**SSD-23700028: Response to Submissions (RtS) Tallawang Solar Farm - Castlereagh Highway (HW18), Tallawang**

TNSW has reviewed Transport Impact Assessment (TIA) prepared by Aurecon, dated 9 April 2024, Reference P521009, Revision D and requests updates to the project's traffic transport impacts on the State road network. Details of the requested additional required are set out in **Attachment 1** and **Attachment 2**.

### **SSD-23700028 Response to Submissions (RtS) - Tallawang Solar Farm, Castlereagh Highway (HW18), Tallawang**

**Figure 1 – Diagram demonstrating trailing taper issue raised in point 1**

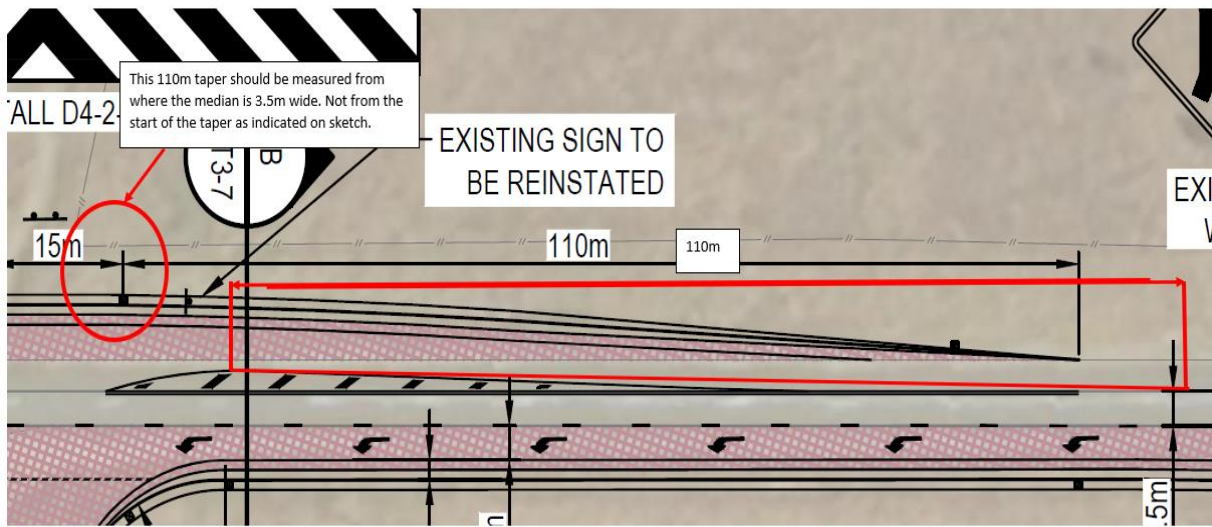
1. The trailing taper for the AUL is required to be measured from the point where the median is 3.5m (refer to figure 1 in Attachment 2). The strategic design must be revised to address this point and ensure the trailing taper is compliant with *Austroads*.

**Figure 2 – Diagram demonstrating extension of the AUL required opposite Jenkins Lane raised in point 3.**

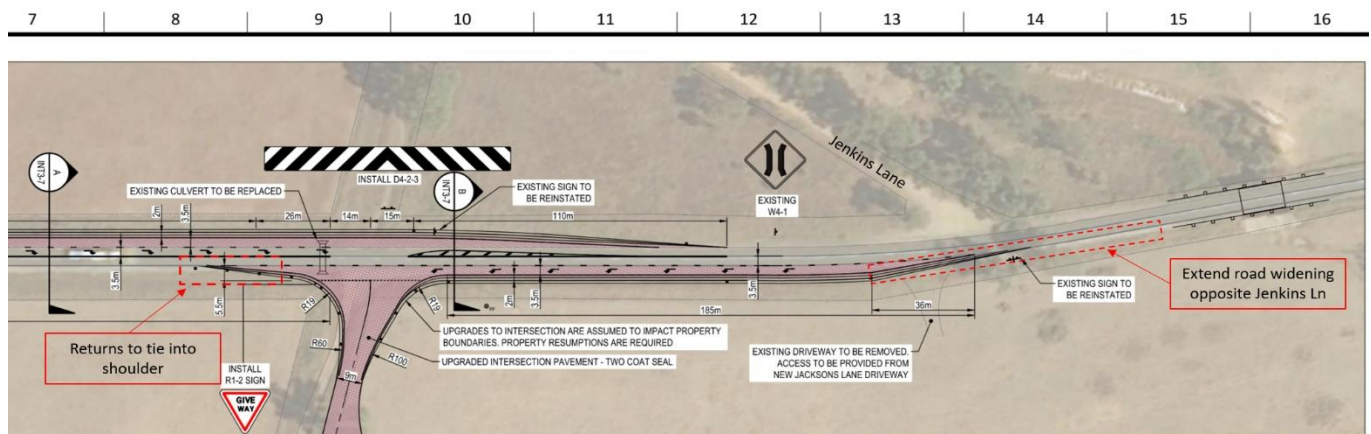
3. The strategic design is to be amended to show the proposed AUL extending past the intersection of Jenkins Lane (refer to figure 2 within Attachment 2) to accommodate the safe turning of entering and exiting the property access onto Castlereagh Highway.
